Product Obsolescence Memo

CHIP DIODES

Bourns® Model CDDFN2-T3.3LC Surface Mount TVS Diode to be Discontinued

*Model CDDFN2-T3.3B
Bottom View*

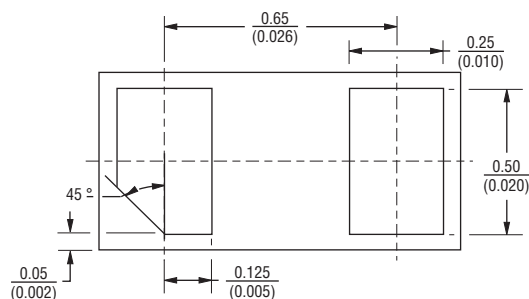
Bourns will be releasing a replacement device, the Model CDDFN2-T3.3B in October, 2013. The electrical specifications of this replacement device are very similar to those of the Model CDDFN2-T3.3LC with an improved, slightly lower clamping voltage. The package pad dimensions are slightly different and are shown in the figure below.
